AGENDA
PLANNING COMMISSION REGULAR MEETING
Wednesday, April 19, 2023, at 6:00 PM

Date: 9.12.22 Resubmitted: 12.16.22, 2.7.23
 Project Name/Contact: Ziggi's Severance/Paul Bass (TST)
 Project Address: 9843 E. Harmony Road
 Customer/Project Number: 284 - American Eagle Properties attn. Jerry Helgeson
 Review Number: 3rd Submittal
 Project Coordinator: Abdul Barzak, Town Planner
 Recipients:

SUBJECT: Ziggi's Coffee – Site Plan

ZIGGI'S SEVERANCE SITE PLAN

DETAIL W-15

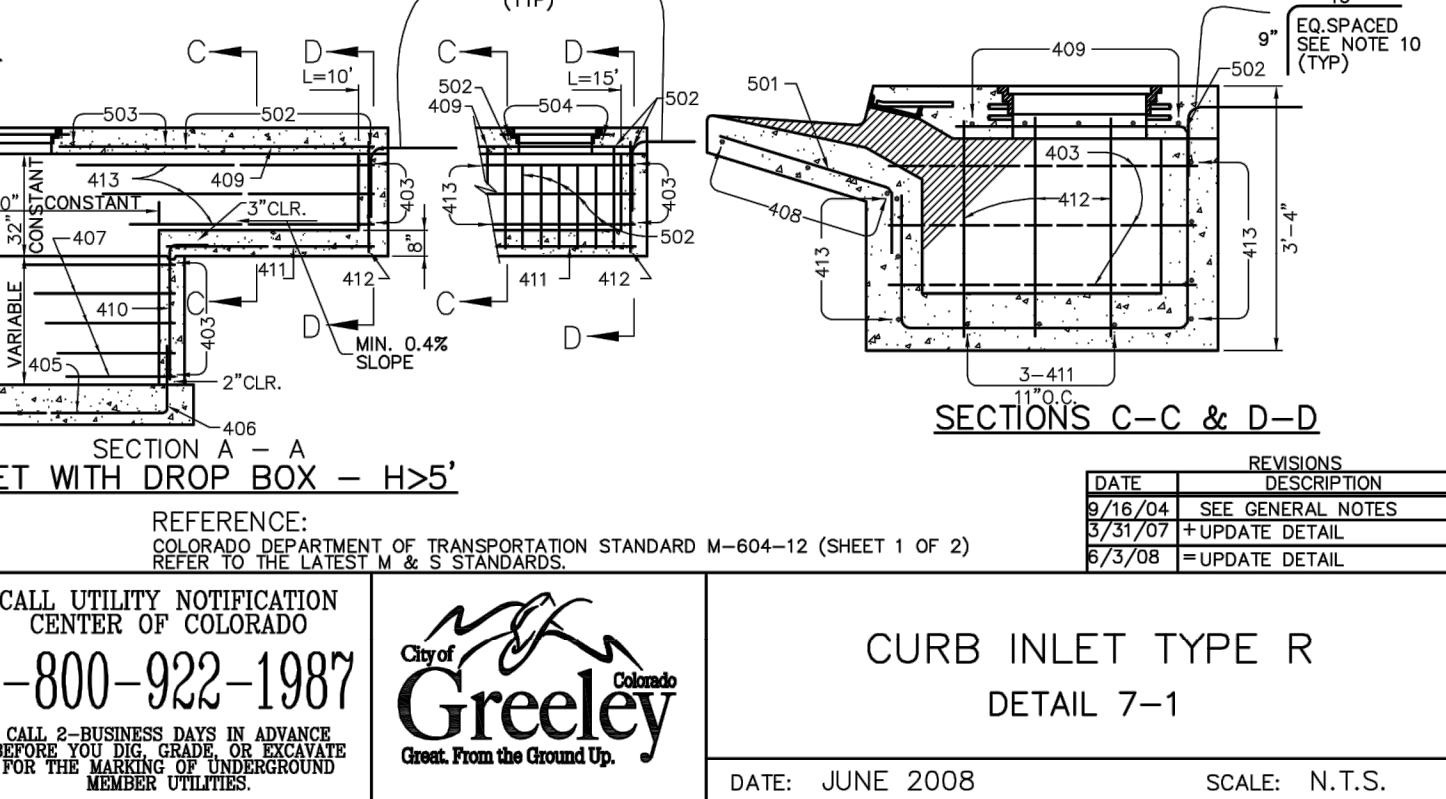
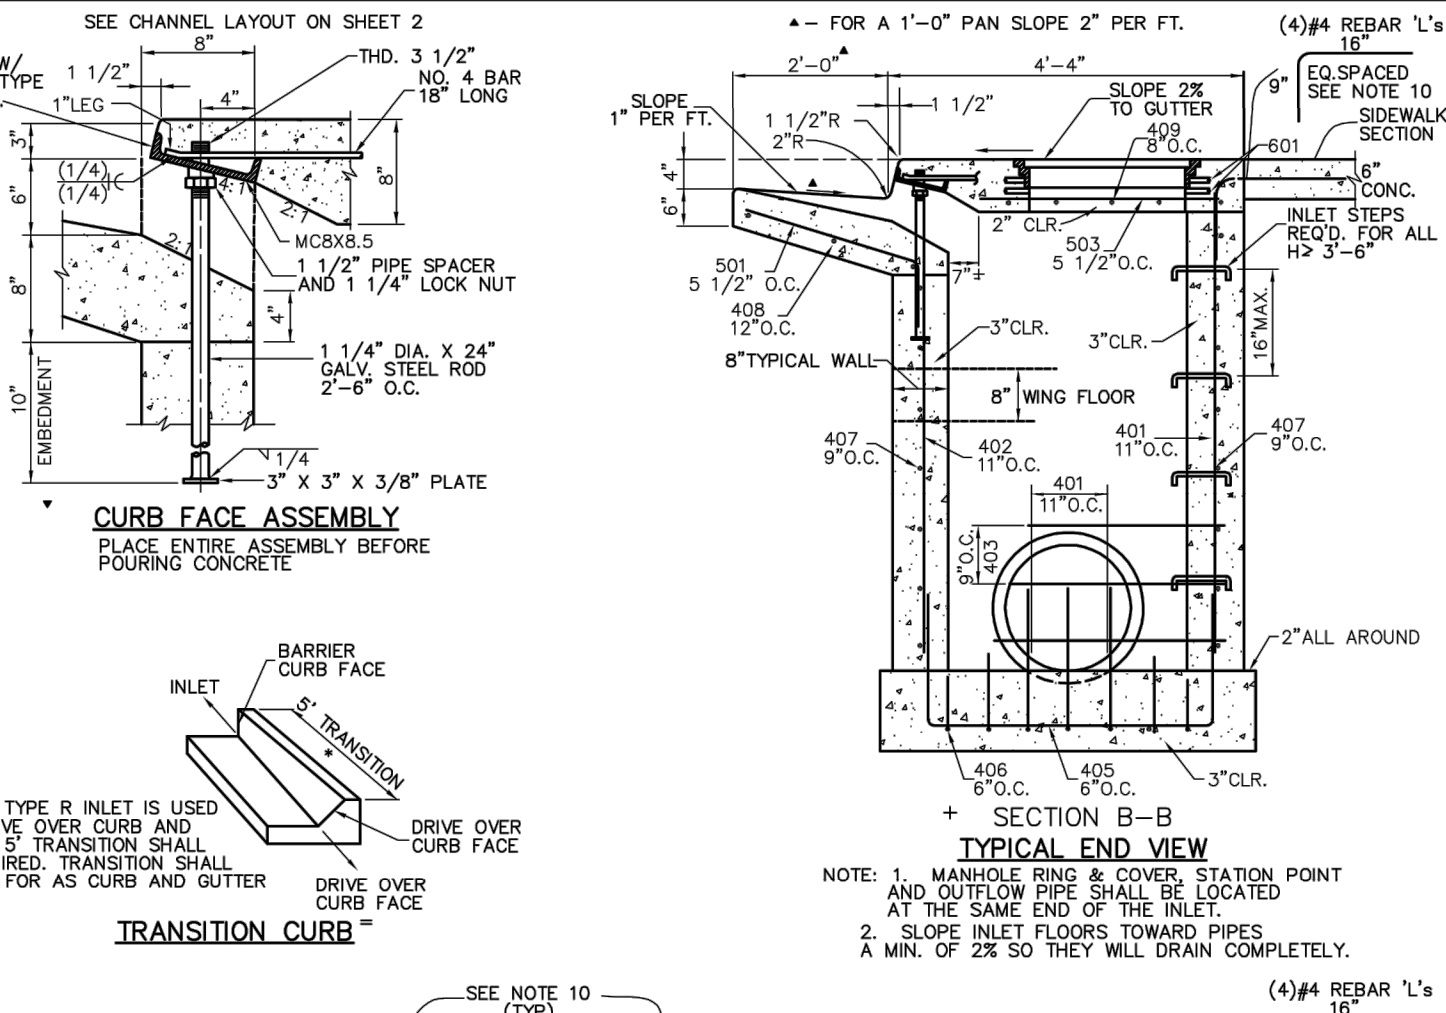
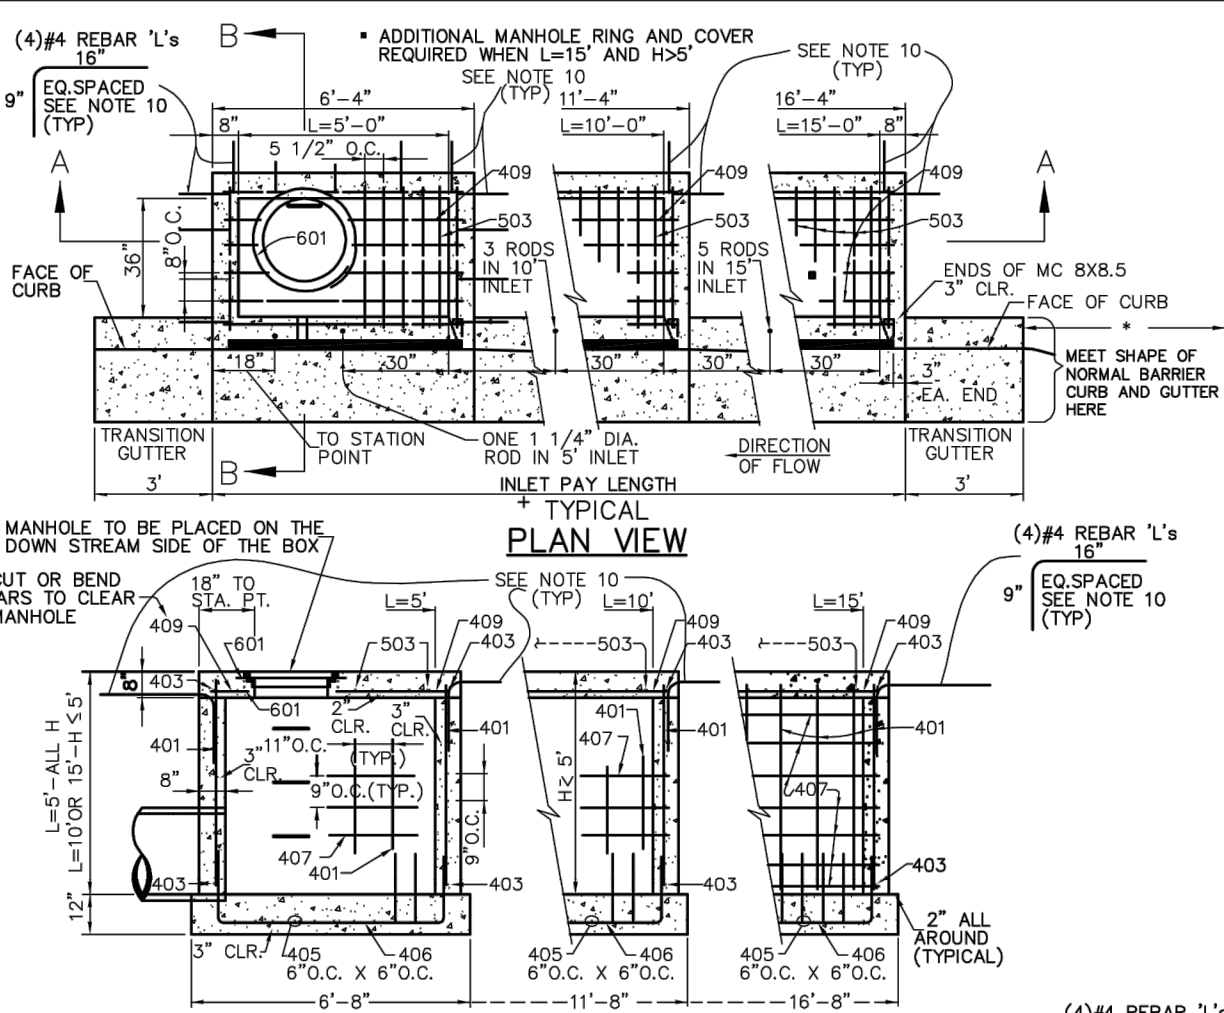
21. Sheets 9-10 (Water Details) – The City of Greeley has updated their Water and Sewer Design Criteria and Construction Specifications as of January 2023. The Town of Severance needs to review the updated 2023 City of Greeley details and determine which details are appropriate for this project.
22. Sheet 11 (Detail) - Add a pavement section detail for the Recommend Pavement Thickness for E Harmony Rd per Table 4 & 5 of the Geotechnical Report titled “Geotechnical Exploration Letter Harmony Centre Severance, Colorado” prepared by Olsson dated July 22, 2019 revised September 23, 2019. *(repeat)*
23. Refer to the Site Plan redlines for any additional comments.
